INSPECTION REPORT FOR
PRIVATE SEWAGE SYSTEMS

PROPOSED SEPTIC SYSTEM FOR SCOTT LUCAS, RFD, DESOTO, WIS.

Amended Plan for Scott Lucas Septic System NW 1/4 Sec 10 T 11 N. R. 7 W TWP - Lot 6 Wheatland, Wernon, DeSoto, WI

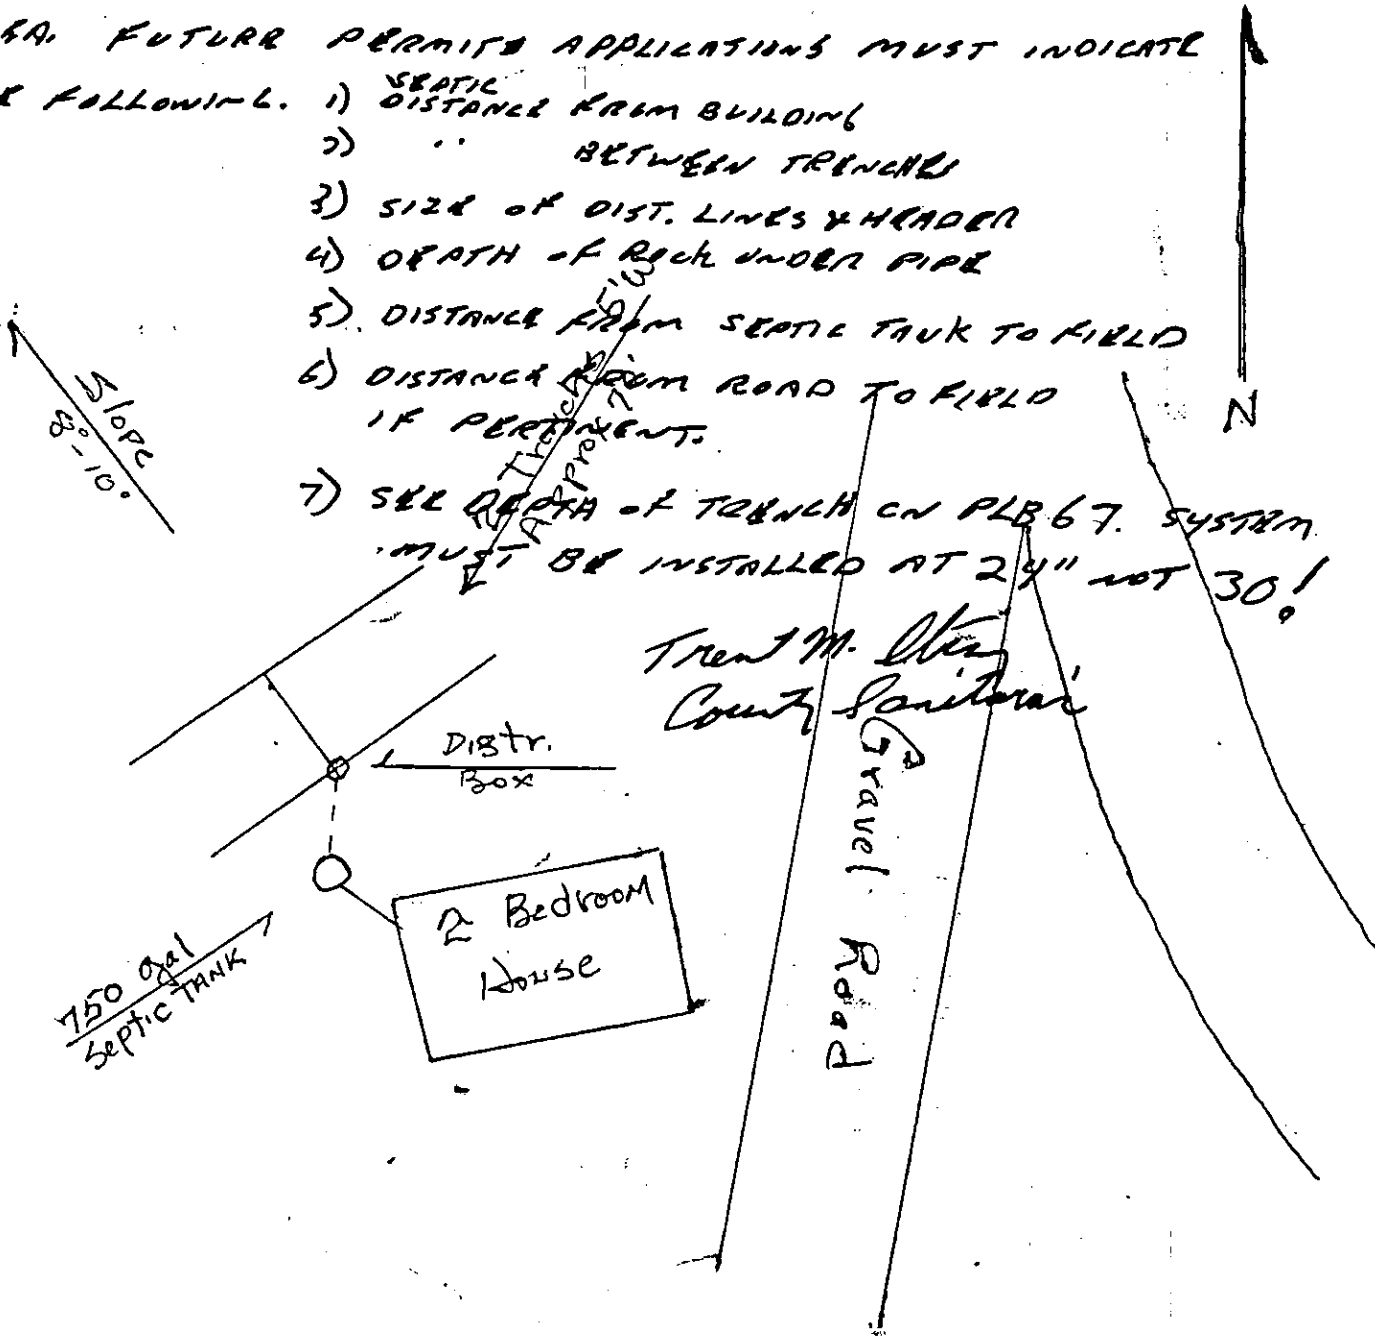
BACKHOE PITS ARE PRESENT TO MARK LOCATION OF SYSTEM AREA. FUTURE PERMITS APPLICATIONS MUST INDICATE THE FOLLOWING:

- 1) SEPTIC DISTANCE FROM BUILDING
- 2) " BETWEEN TRENCHES
- 3) SIZE OF DIST. LINES & HEADER
- 4) DEPTH OF ROCK UNDER PIPE
- 5) DISTANCE FROM SEPTIC TANK TO FIELD
- 6) DISTANCE FROM ROAD TO FIELD IF PERTINENT.
- 7) SEE DEPTH OF TRENCH ON PLB 67. SYSTEM MUST BE INSTALLED AT 24" NOT 30!"

PROPOSED SEPTIC SYSTEM FOR SCOTT BUCAS, RFD, DESOTO, WI.

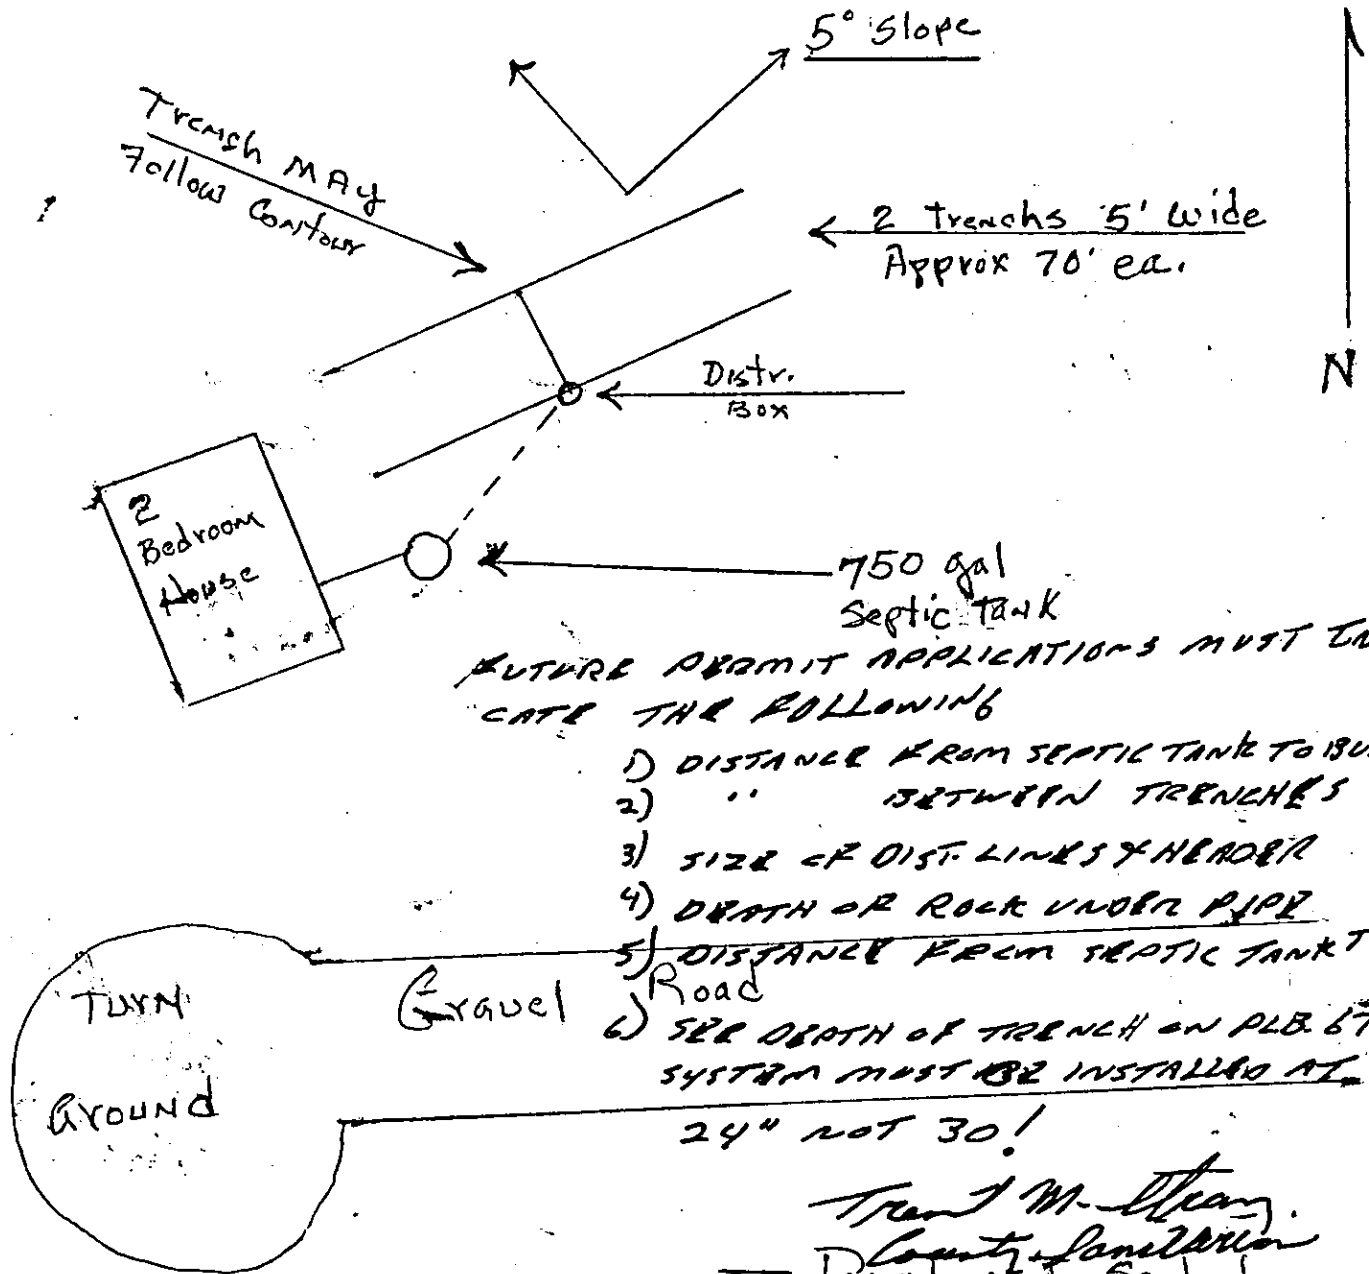
FUTURE PERMIT APPLICATIONS MUST INDICATE THE FOLLOWING

- 1) DISTANCE FROM SEPTIC TANK TO BUILDING
 - 2) " BETWEEN TRENCHES
 - 3) SIZE OF DIST. LINES & HEADER
 - 4) DEPTH OR ROCK UNDER PIPE
 - 5) DISTANCE FROM SEPTIC TANK TO FIELD
 - 6) SEE DEPTH OF TRENCH ON PLB. 67.
- SYSTEM MUST BE INSTALLED AT 24" NOT 30!
